Name: Monument Hghts Townhomes – W. Kennedy Ave. W. of Juniper St.-Preliminary Plan

TITLE HEADING: Preliminary Plan - Monument Heights Townhomes

# REVIEW COMMENTS

# RESPONSE TO REVIEW COMMENTS

PRELIMINARY PLAN  
 MONUMENT HEIGHTS TOWNHOMES

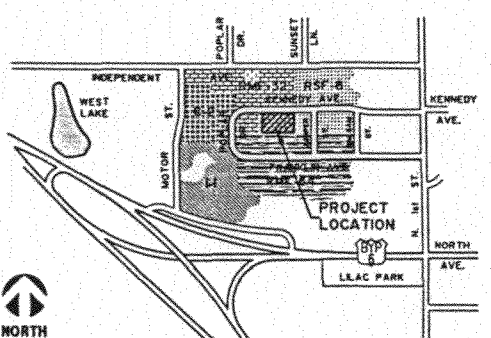
A fire flow survey is required. Submit plans showing construction type and size of buildings along with a site plan showing distances between buildings on all sides. The site plan must also show the existing water main size and distances to existing hydrants. All new structures must be located within 150' of a fire hydrant.

1. Show how water and sewer services will be provided since each townhome will require its' own separate sewer service and probably separate water service unless some type of pre-arranged agreement is worked out and filed with each individual property.
2. Show proposed location of additional fire hydrant or hydrants.

It appears the separation between the parking aisles - 44' - is more than sufficient. Code requires only 25' - the asphalt area could be reduced. Parking blocks or curbing should be provided.

1. Structures must meet the required rear yard setback of 20 feet (RMF-32) from the south property line. The patios, as long as they are open and uncovered, may extend into this setback up to 6 feet.

2. Construction of curb, gutter, sidewalk and pavement (if necessary) is required along W. Kennedy as shown on the plan.
3. The parking area should be narrowed to minimize the expanse of pavement between the buildings and in the front yards of these units. The aisle could be narrowed to the 30' proposed for the driveways. With the 20-foot parking spaces, the total bay width could be 70 feet rather than the 84 feet shown on the plan. There would be no need to stagger the parking on the south end with the narrower design.

4. If there is a possibility that the driveway could continue on through to the property to the south, suggest moving the dumpster location so it does not have to be disturbed at a future phase.

A fire flow survey will be done as well as submitting plans for the construction of the buildings. Sizes and distances have been added to the plan.

1. Services will be provided to the buildings from main line extensions into the parking area as shown on the revised plan. This parking area will be in dedicated common open space that can also be dedicated as a utility easement.

2. Proposed fire hydrant is shown on the revised plan.

The parking area has been reduced by approximately ten feet. Parking blocks or curbing will be provided and will be shown on the Final Site Plan.

1. The plan has been revised to show the buildings meeting the 20-foot setback requirement.
2. Curb and gutter is being proposed along West Kennedy.
3. The parking area has been reduced and is shown on the revised plan.
4. The applicant is still pursuing the requirement of providing a dumpster. If the dumpster is required, this still remains the logical place for it. If in the future development occurs that would make it advantageous to continue access through the two sites, it does not appear that it would be difficult to modify its location slightly and have it remain in the general area.
5. The listed items will be submitted as required at Final Plat/Site Plan phase.
